CLIVE PLANNING & ZONING COMMISSION

RE: Site Plan - Linnan Park - 8500 Alice Ave

Re: 8500 ALICE AVE - Linnan Park - Site Plan

90% Revised Set

CU101

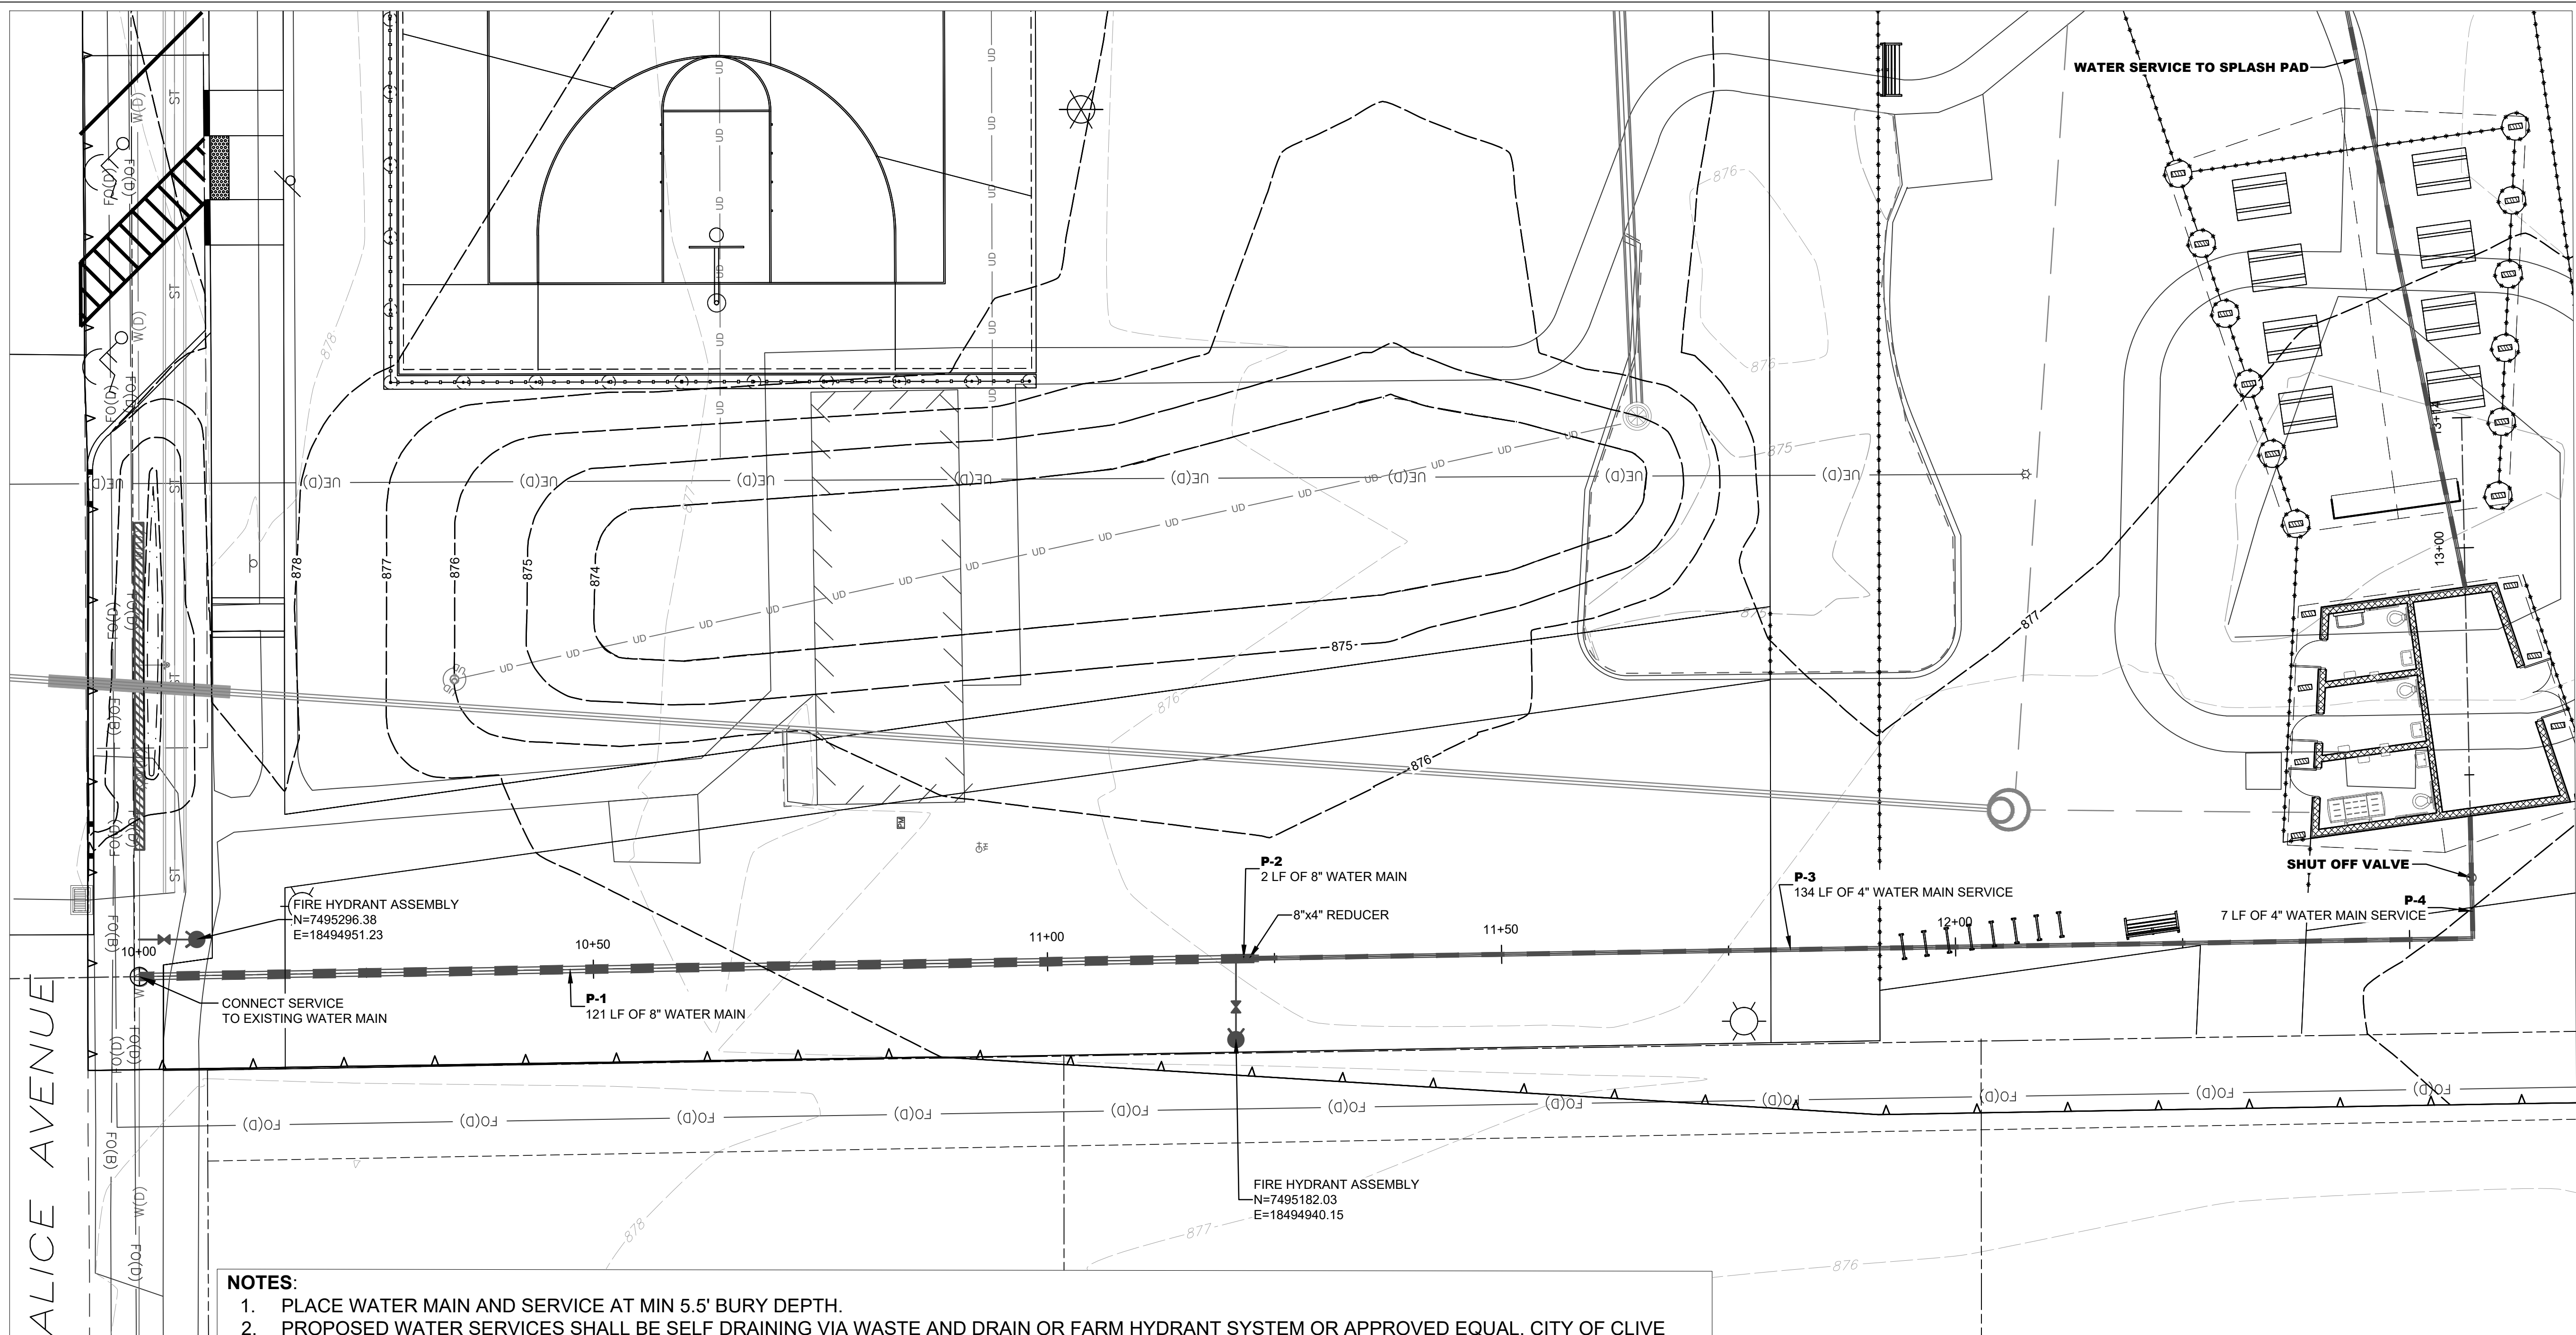
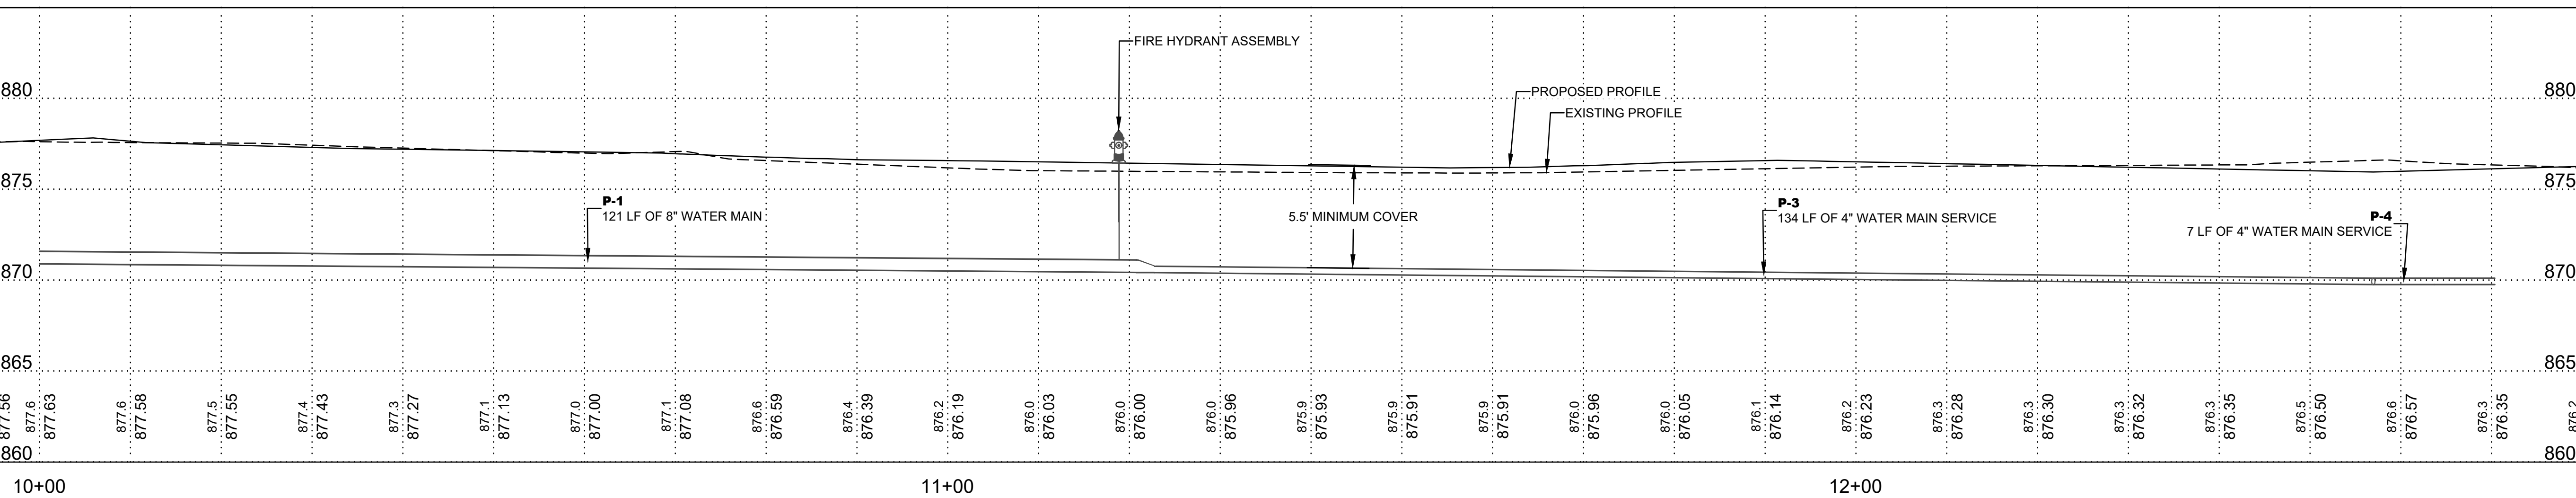
14. Model Output pg 28-- Bioretention cell 3 rim does not appear to match plan set; this could be a staff error. The plan set bioretention cells do not have identifiers, and bioretention cell 3 label was not located in SWMP. In any case, it was modeled with the rim at 875.93 and ST 32 rim elevation is 875.00. Cross reference CU101.

15. Model Output pg 30-- SWMP Bioretention cell 4 rim does not appear to match plan set; this could be a staff error. The plan set bioretention cells do not have identifiers, It was modeled with the rim at 875.50 and ST 42 rim elevation is 874.75. Cross reference CU101.

3. CU501 label the detail with the respective structure number ST-15. Adjust note one to indicate the structure, including the base and the walls, are to be cast in place as separate pours. Provide details or notes on how to adjust the structure at a later time to remove the conflict pipe.

4. Provide additional detail on Storm Structure ST-15 in plan view on Sheet CU101 and on Detail Sheet CU501. City staff's understanding is that the preferred option and final design details at this location are still being refined by V&K. After discussion with V&K, the preference would be to realign and construct an SW-505 double intake in the parking lot and connect to a downsized ST-15. The 12'x 6' special structure seems oversized as currently designed for what may be an interim condition.

7. CU100, CU102 - 877 contour near sidewalk flume does not match CG101
8. CU101-- Bioretention cell 3 rim does not appear to match plan set; Cross reference SWMP.

9. CU101-- Bioretention cell 4 rim does not appear to match plan set; Cross reference SWMP.
10. CU100 - Bioretention cell 4 missing cleanout information.

11. CU101 - Bioretention cell 6 missing flared end section label.
12. CU101, CU501-- Revise parking lot structure (conflict box) per discussion.
13. CU501, Special Provision - add note that acceptance of bioretention construction is based on demonstration that the WQv will draw down in 24 hours. This is a request based on a council concern about performance.
